New Beith Rail Overbridge

Design Report

Rev H

Review Comment Responses

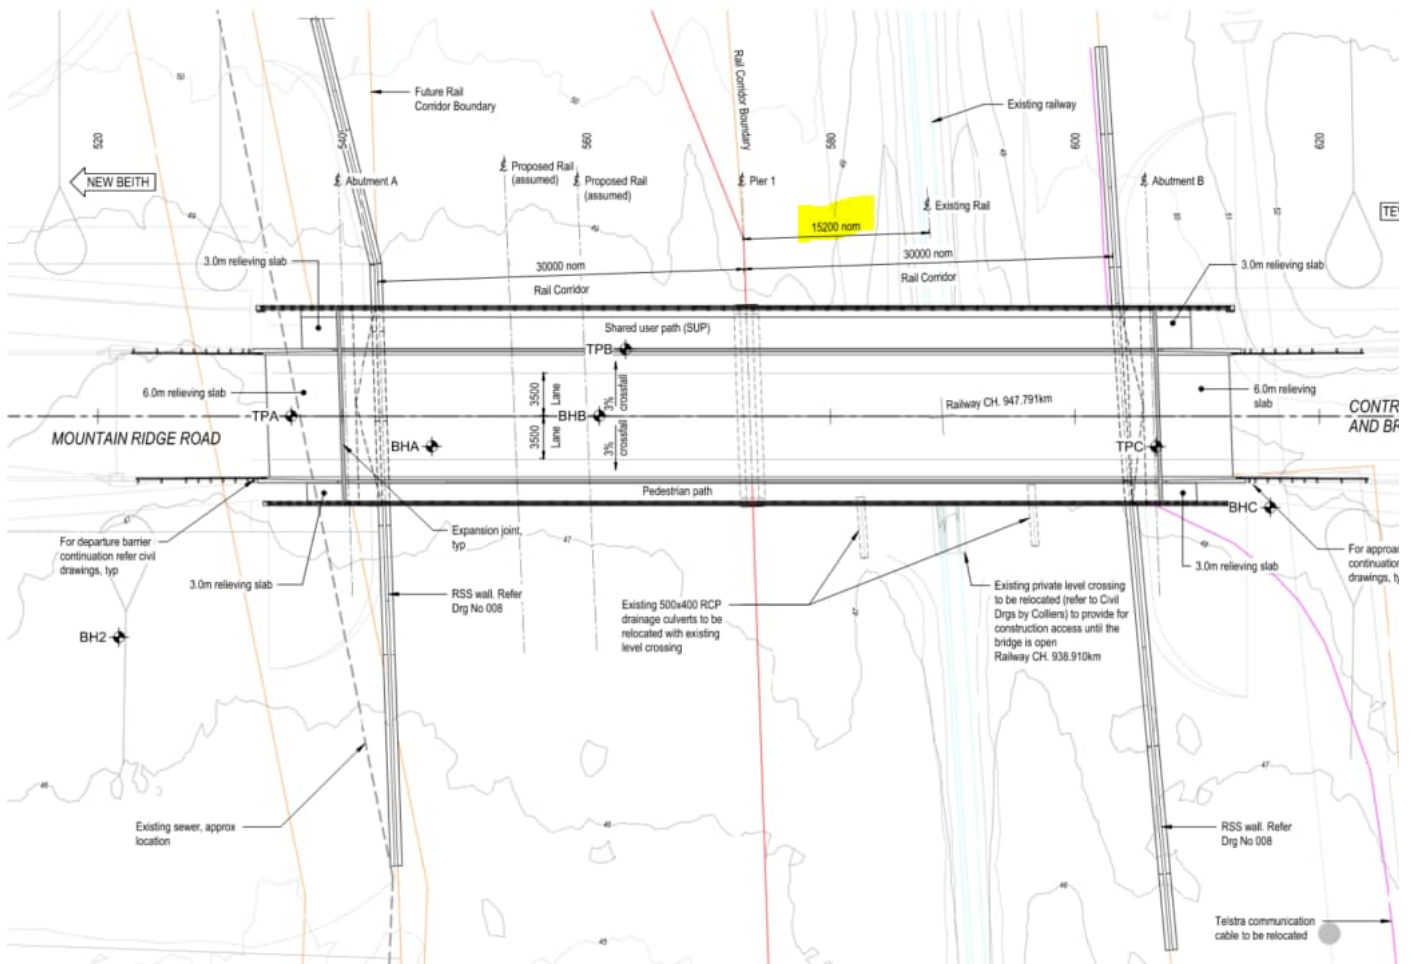
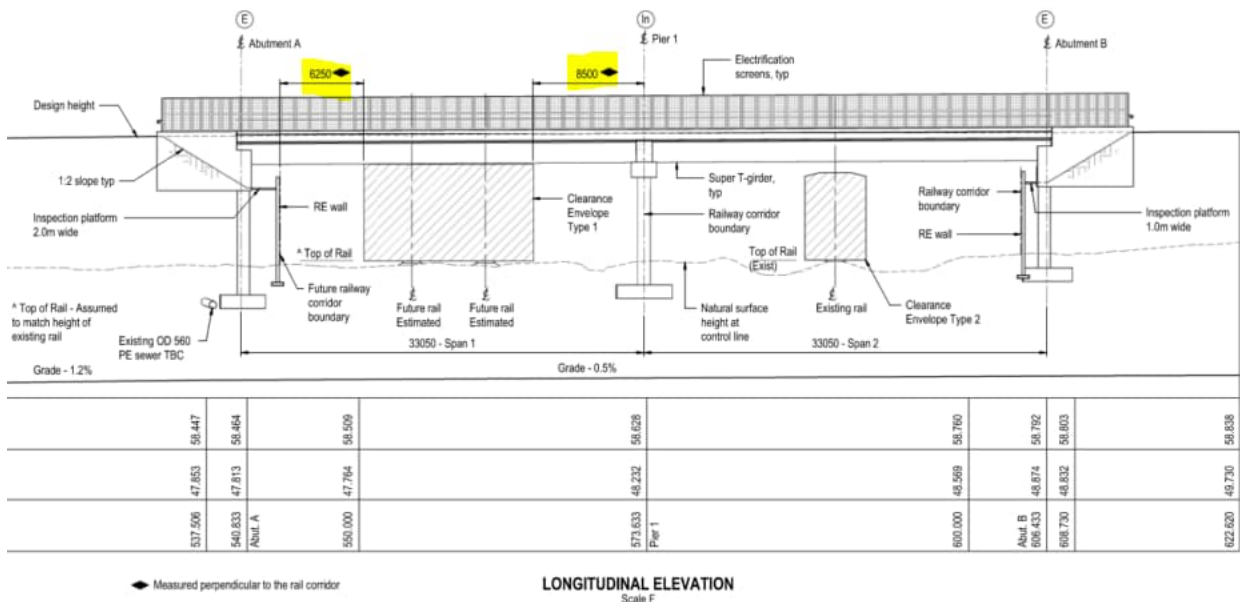
- a) The drawing references the old clearance drawing 2754, this should be QR-C-S3306.
- b) Track centres should be dimensioned out as per Drawing QR-C-S3307.
- c) The drawings are to space proof future collision barriers (pier and abutment).
- d) The constructability of the crash barriers needs to be considered and explained, noting piling under an existing bridge below the span will be an issue. The relevant information needs to be stated on the drawing.
- e) Attached materials indicate Pitt & Sherry has carried out risk analysis based on track engineering control and non-track engineering controls and complying to AS5100.1, AS5100.2, Civil-SR-012, ARTC EIS-09-00 and concluded that the deflection wall can be waived along span 1. TMR acknowledges your advice that this has been accepted by ARTC.

The horizontal clearance between the existing track centreline and the pier is shown on the plan. I have highlighted it below:

Note that we haven't specified clearances to the future QR railway on the plan as these haven't been defined at this stage. We have shown indicative dimensions for these on the elevation however:

Vertical clearances are only shown by way of the clearance envelopes which are defined on the same drawing as the elevation above (Drg 003).
